APPLICANT'S RESPONSES TO ISSUES RAISED AT DEADLINE 2 (UPDATED)

Drax Bioenergy with Carbon Capture and Storage

Document Reference Number: 8.10.2

Applicant: Drax Power Limited

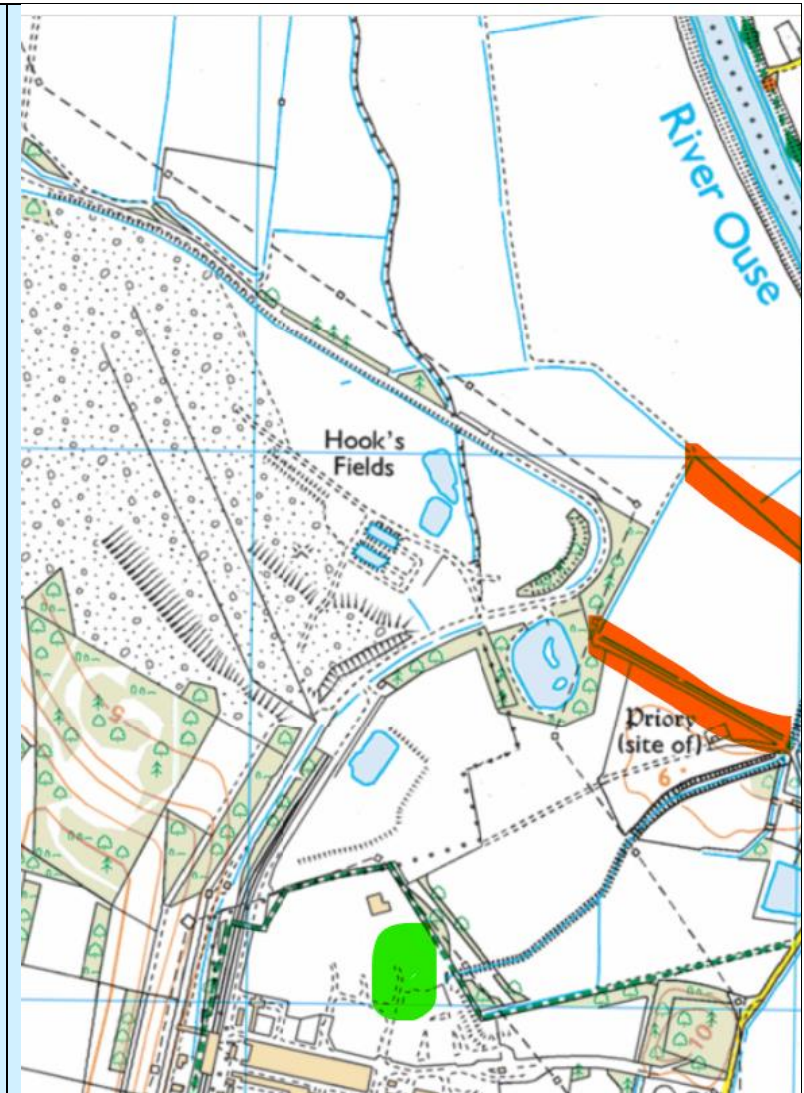
6.4 (para 7)	Appendix A – CEMP Watercourse Pollution Prevention Plan We welcome the plan in Appendix A which shows the CEMP Watercourse Pollution Prevention Plan boundary. Whilst this is in line with previous discussions, we have had with the Applicant we wish to reiterate that included in the CEMP should be justification for any water features within the 500m buffer that are not within this boundary.	The Applicant remains in discussions with the Environment Agency to agree the water features which are excluded from the Watercourse Pollution Plan Boundary. The Environment Agency require justification for the exclusion of the areas marked in yellow in the plan below:

Response Ref. (Location in Original Submission)	Comment	Applicant's Response
		<p>In the yellow area the OS mapping shows that there are only two minor watercourses of significance, they are highlighted in red in the plan below:</p>

The Applicant considers that these watercourses do not need to be included in the watercourse prevention plan as the Carr Dyke provides a cut off from the works and will therefore prevent pollution reaching much of

Response Ref. (Location in Original Submission)	Comment	Applicant's Response
		<p>the yellow area and the only works proposed north of the Carr Dyke are as follows:</p> <ul style="list-style-type: none"> A) The AGI terminal in the main site boundary (green mark in the above plan), any surface water runoff / accidental spills would preferentially flow into the Carr Dyke (assuming drainage / mitigation systems are bypassed – i.e. full at the time of the spill). B) BNG planting, which is envisaged to be tree whips planted by hand which are not anticipated to result in environmental impacts. <p>Furthermore, the IDB pumping station on the Carr Dyke / River Ouse confluence will pump waters into the River Ouse preventing back flow (i.e. any waters containing contaminants) up the small channels (highlighted in red in the above plan) apart from times of extreme flood. During times of extreme flood there would be significant dilution of pollutants by flood water, and measures in the CEMP (as secured in the draft DCO Requirement 14) would be implemented as detailed in the REAC (REP02-053 to be submitted at Deadline 3), in particular WE10 and WE14, which would prevent works taking place that are most likely</p>

Response Ref. (Location in Original Submission)	Comment	Applicant's Response
		<p>to generate pollution and would manage and mitigate a pollution event should one occur. These measures together would result in minimising the risk of pollution occurring overall.</p> <p>The Environment Agency have agreed with this on the basis that the Carr Dyke does provide a cut-off and that the measures set out in the REAC (particularly WE14 which requires a Watercourse Pollution Prevention Plan to be prepared and agreed with) ensure that no run-off that may enter Carr Dyke in case of an accident, may escape and enter the nearby drains. Further evidence will be provided to the Environment Agency as part of the submission of the Watercourse Pollution Prevention Plan, which is to show the outline flow of these watercourses and demonstrate there is no connectivity. Should conditions change, for example excessive wet weather, the Watercourse Pollution Prevention Plan will be reviewed and revised as necessary. This has been captured in the REAC (REP02-053 to be submitted at Deadline 3).</p>
